Re: Finance Docket No. 35095, The Alaska Railroad Corp. -- Petition For An Exemption From 49 U.S.C. §10901 To Construct and Operate a Rail Line Extension to Port MacKenzie, Alaska

Per your March 20, 2009 information request, and on behalf of the Alaska Railroad Corporation and with the support of the Matanuska-Susitna Borough, enclosed please find our responses regarding your requests 1-5.

Re: Big Lake Alternative Stream Relocation and Rail Crossing

Stream Relocation and Railroad Crossing

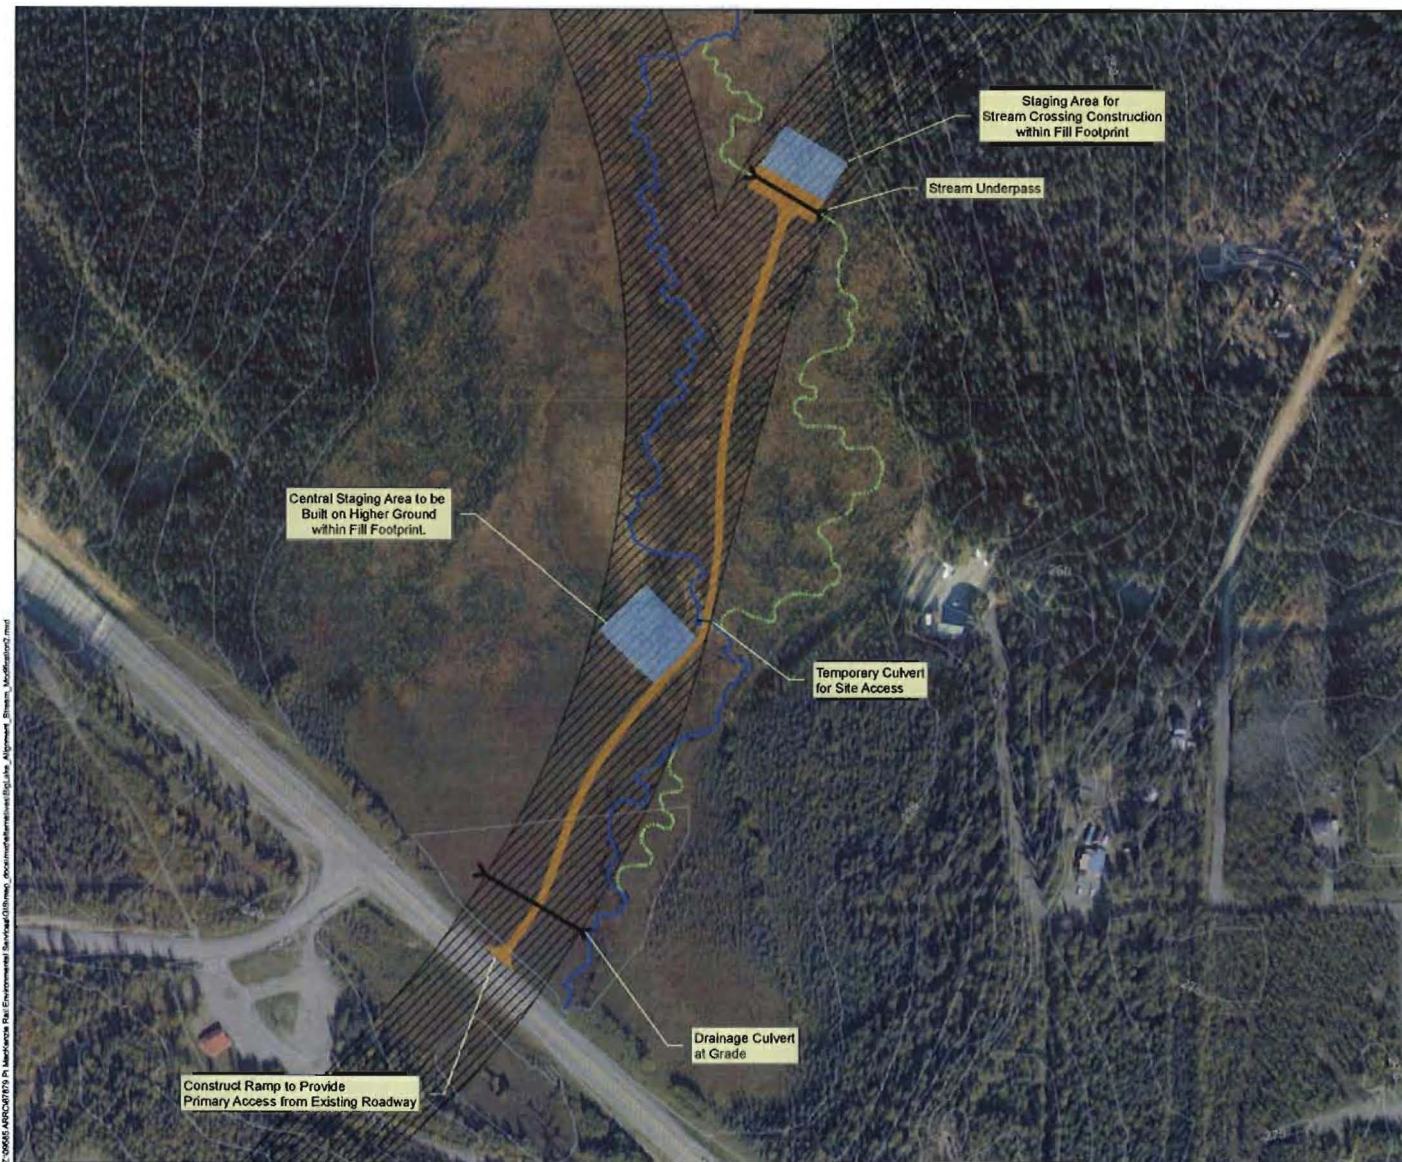
Request 3: Typical cross section of the anadromous stream relocation design and anticipated footprint for construction, including equipment access and staging areas, if required.

Response: See attached memo and exhibits.
